# UNITED STATES PATENT AND TRADEMARK OFFICE

APPLICATION NO.	FILING DATE	FIRST NAMED INVENTOR	ATTORNEY DOCKET NO.	CONFIRMATION NO.
10/758,012	01/16/2004	Tomoyuki Kojima	0051-0217P	5749

<b>Office Action Summary</b>	<b>Application No.</b> 10/758,012	<b>Applicant(s)</b> KOJIMA ET AL.	
	<b>Examiner</b> WILLIAM MCCALISTER	<b>Art Unit</b> 3753

## **DETAILED ACTION**

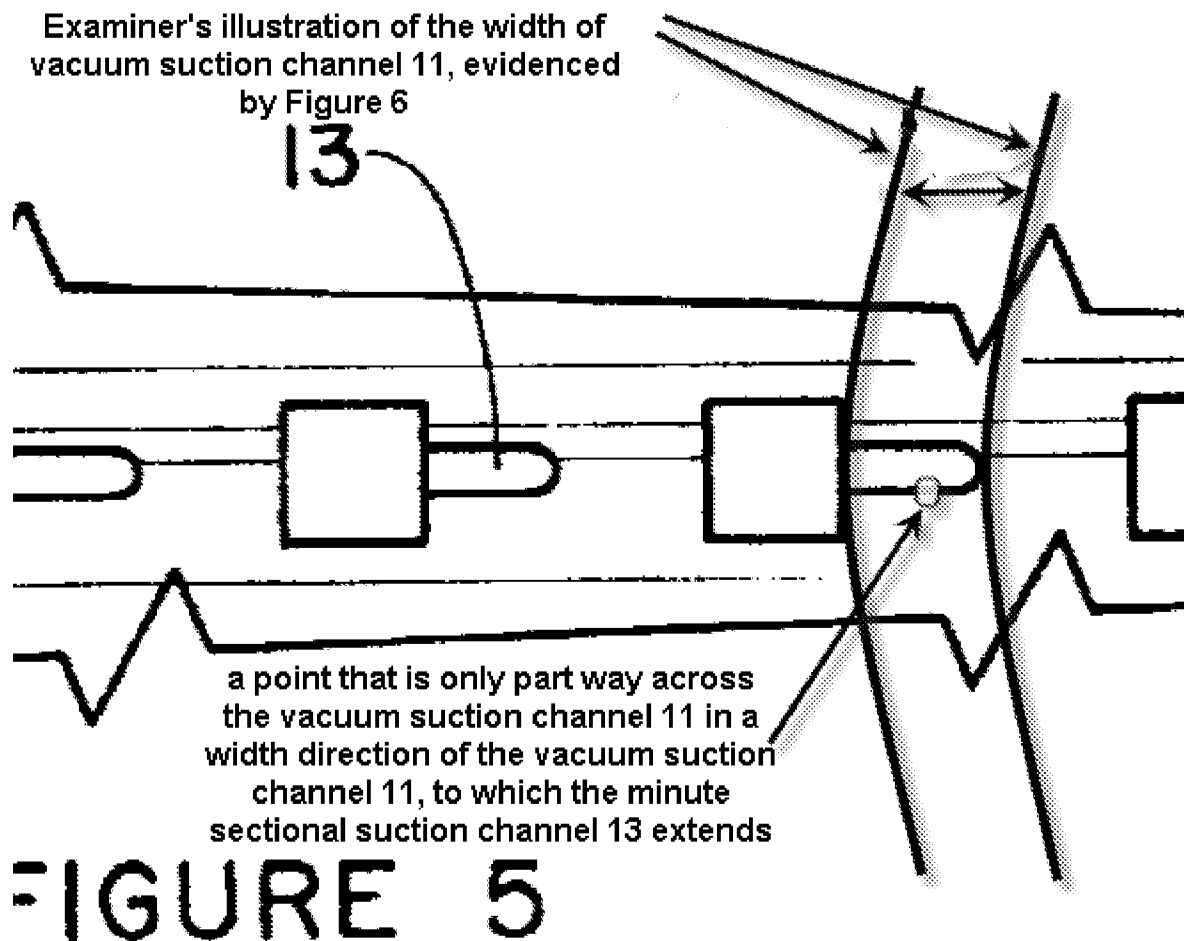
- a plurality of work receiving openings (10) penetrating through the conveyor table (8) (see FIG 6) for receiving works therein (such as members 12), the work receiving openings (10) being spaced apart from each other and arranged in a circular pattern (see FIG 4),

- each work receiving opening (10) being disposed (radially) outwardly relative to the vacuum suction channel (11),

- each work receiving opening (10) being connected to the vacuum suction channel (11) through a minute sectional suction channel (13) provided on the conveyor table (8),

each of the minute sectional suction channels (13) has an axis extending in a direction (from left to right, as seen in FIG 5) that is orthogonal to an axis (from top to bottom, as seen in FIG 6) of the corresponding work receiving opening (10), and extends from the corresponding work receiving opening (10) to a point that is only part way across the vacuum suction channel in a width direction of the vacuum suction channel (see annotated FIG 5 below), thereby providing a pressure resistance when the vacuum generation mechanism is operated (all conduits provide pressure resistance because of frictional losses associated with the contact between flowing fluid and the conduit walls).
